Response to Second  
PEA Completeness Review

# Ventura Compressor Modernization Project

**JULY 2024**

Exhibit 1. 1.0 psi Overpressure Injury Risk Contours – Existing Ventura Compressor Station

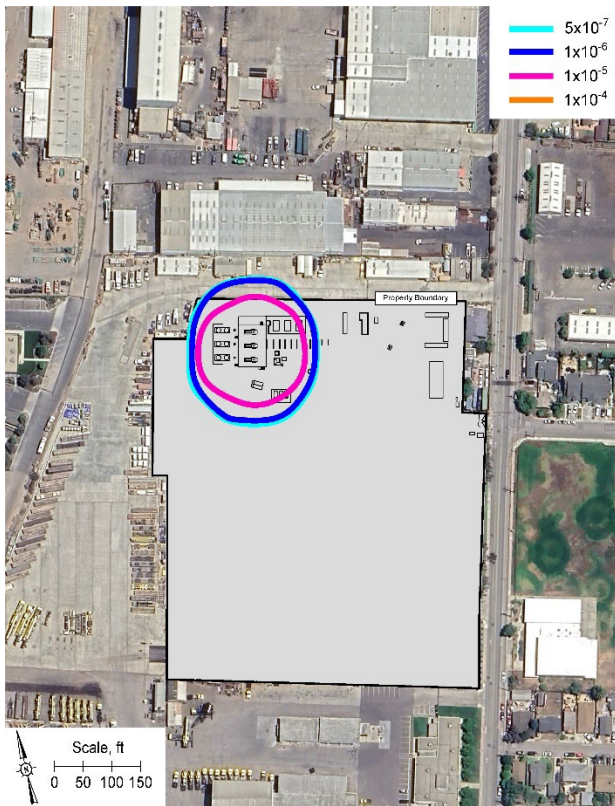
**CPUC Comment No. 9:** *Please add hazard modeling endpoints for explosion overpressure at levels less than 2.4 pounds per square inch (psi) to inform the scope of potential serious injury. For example, to assess probability of off-site injury, please include explosion overpressure endpoints of 1.0 psi to 0.70 psi.*

**Response to CPUC Comment No. 9:** The QRA was based on fatality impacts to persons outdoors. Thus, the 2.4 psi overpressure value represents the threshold of fatality, and the lowest overpressure endpoint within the QRA. Following discussion with the CPUC and its consultants, the 1.0 psi overpressure level was selected for evaluation. 1.0 psi is a common overpressure endpoint that is typically associated with partial damage to ordinary buildings that could result in injuries.<sup>1</sup> Note that 1.0 psi is unlikely to have serious effects on persons outdoors. The explosion overpressure calculations from the QRA were rerun, and injury risk contours for exposure to 1.0 psi overpressure were created. These are shown in Exhibit 1 for the existing Ventura Compressor Station and in Exhibit 2 for the proposed Project.
